# Access Compliance Report

## Public Rights-of-Way

### (Curb Ramps)

Intersection ID: 52363	Main Street: DUNAVANT_ST	Cross Street: IRONSIDE_AV	Location: S
ADA ID: 246799BC2B0F	Ramp Type: Directional1	Initial Pass/Fail: Fail	Overall Compliance: No
Codes/Mitigation Info/Possible Solution		Field Measurements/Component Compliance	
Severity Score: 13.75

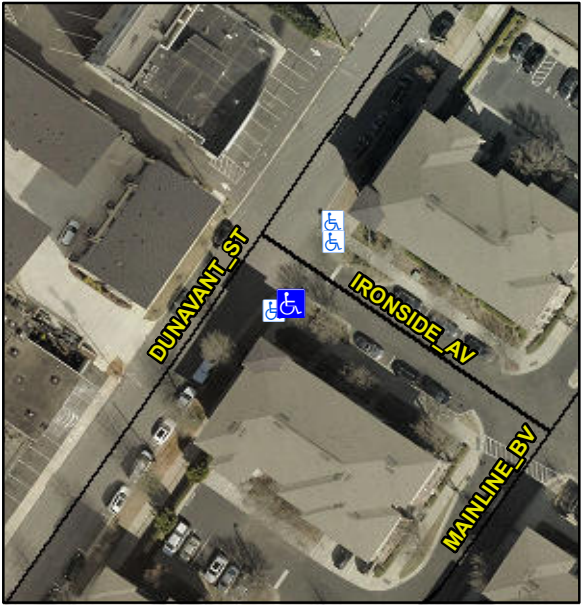
Possible Solutions:				
	Remove & Replace Entire Ramp.				
	Surveyor Notes:				
	N/A				
	PROW/ADA:				
	R304.2.2, R304.5.3				
	Street 1 Name	IRONSIDE AV			
	Stop Condition-Street 1	StopSign			
	Street 2 Name	N/A			
	Stop Condition-Street 2	N/A			
Total Cost:		\$	1600.00		
		Compliance	Description	Data	Compliance Description Data
		N/A	Ramp Length (in)	78.0	N/A Grade Break? N/A
		Yes	Ramp Width (in)	96.0	N/A Grade Break Slope (%) 0.0
		No	Ramp Slope (%)	10.8	N/A Grade Break XSlope (%) 0.0
		No	Ramp XSlope (%)	3.9	
		N/A	Flare Type LT	N/A	N/A Flare Type RT N/A
		N/A	Flare Slope LT (%)	N/A	N/A Flare Slope RT (%) 0.0
		N/A	Flare Traversable LT?	N/A	N/A Flare Traversable RT? N/A
		N/A	Landing Length (in)	0.0	N/A DWS Provided? N/A
		N/A	Landing Width (in)	0.0	N/A DWS Contrast? N/A
		N/A	Landing Slope (%)	0.0	N/A DWS Length (in) N/A
		N/A	Landing X Slope (%)	0.0	N/A DWS Full Width? N/A
		N/A	Landing Curb? (Y/N)	N/A	N/A DWS Offset LT (in) N/A

N/A	Shared Landing?	N/A	N/A DWS Offset RT (in) N/A
		N/A	Gutter Ponding?	0.0	N/A Gutter Slope (%) N/A
		N/A	Gutter Lip Ht (in)	0.0	N/A Gutter X Slope (%) N/A
		N/A	Painted X Walk1?	No	Road Slope (%) 2.3
			X Walk 1 Direction	To NE	Road X Slope (%) 1.0
			X Walk 1 Width (in)	N/A	Clear Space? N/A
			X Walk 1 Slope (%)	2.3	N/A Clear Space to XWalk (in) N/A
			X Walk 1 X Slope (%)	1.0	N/A Storm Grate/Utility Hazard? N/A
		N/A	Ramp inside XWalk1?	N/A	Storm Grate/Utility Type
		N/A	Any Obstructions?	N/A	N/A
			Obstruction Type		Yes Surface Condition? (G/P) Good
				N/A	N/A Curb Slope (%) 8.7
